Submitted by	Company Name	Submittal Date
Nuo Tang	San Diego Gas & Electric	10/18/2017

SDG&E appreciates the opportunity to comment on the CAISO’s ESDER 3 issue paper. SDG&E provides the following comments to assist the CAISO in shaping the scope of the initiative.

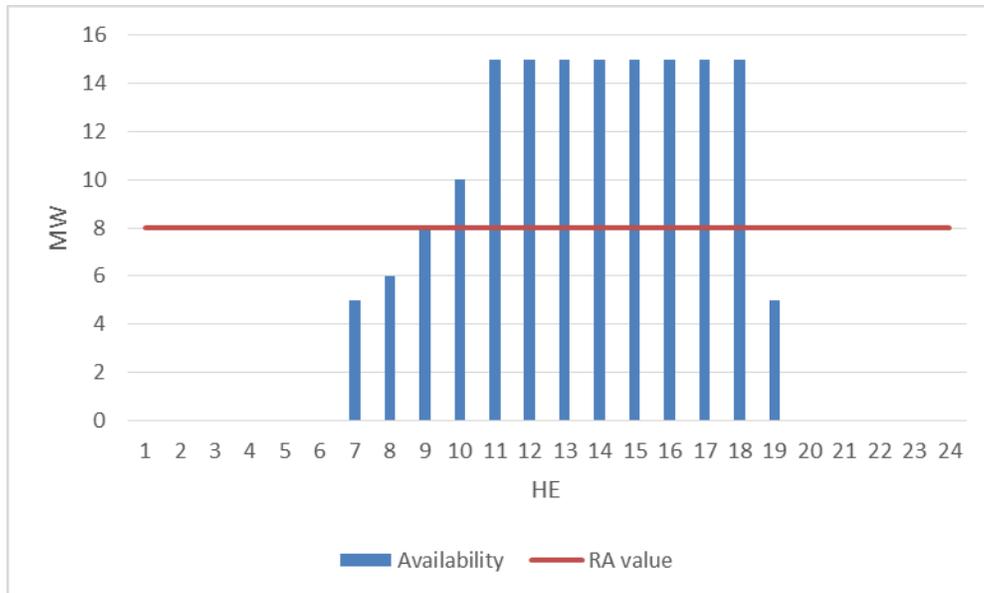
The existing MOO for all resources including PDRs is 24 hours of each day. However, due to the nature of the program, the PDR, including non-weather sensitive programs, may not be available to provide its monthly RA value for every hour of the day, including the program hours. The following example illustrates the availability of such a program.

The non-weather sensitive PDR has a maximum curtailment of 15 MWs, an NQC of 8 MWs and an hourly variable availability as it begins operations. The CAISO’s system does not allow this resource to bid in below the RA value. If the SC bids in 5 MW for HE 19, the CAISO’s system would adjust the bid to equal the 8 MWs RA value because that is the MOO for the resource. Providing the 15-minute bidding option would not prevent the PDR from having to meet its MOO every hour. If the CAISO bids and dispatches 8 MWs but the resource is only capable of 5 MWs, then the CAISO would have 3 MWs of energy it would need to dispatch from other resources on the grid. This would increase costs for ratepayers because the CAISO’s system is not aligned with the operational capabilities of the resource it is dispatching.
